## GP COMPANIES, INC.

### **Subject: EZ Pump (44 Series) Plunger / Guide Improvement**

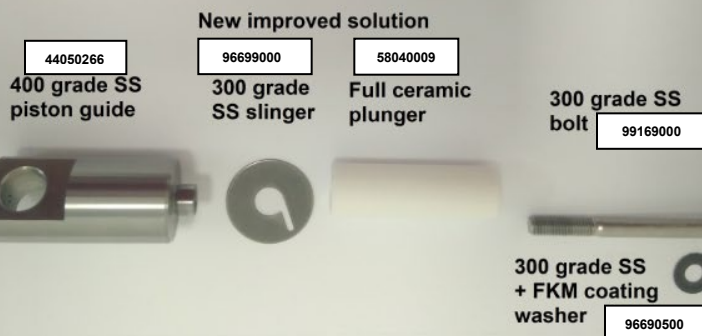
General Pump is pleased to announce the improvement of plunger and plunger guide arrangement for EZ Pumps.

During the 3<sup>rd</sup> quarter, 2021 all versions of the 44 Series pumps ("EZ" prefix) will be converted to new and improved ceramic plungers, plunger guides, and improved retention method. The new style plungers are made 100% from ceramic, which is resistant to flaking caused by thermal changes or "run-dry" situations. Furthermore, the plungers are now retained via a bolt versus nut-on-stud. This improvement prevents water from penetrating the plunger, which can lead to freeze cracks.

Pump performance, weight and dimensions remain unchanged. Pumps seals and repair kits are also unchanged. Existing coated plungers will be available until inventory supplies are exhausted. The new plunger and guide assembly can be retrofitted to current pumps by replacing all components shown below. Pump version will be tracked via Date Code on pump; however, simple identification can be completed visually by observing if the plunger is White (new) or Dark Gray (old) from the underside of the pump.
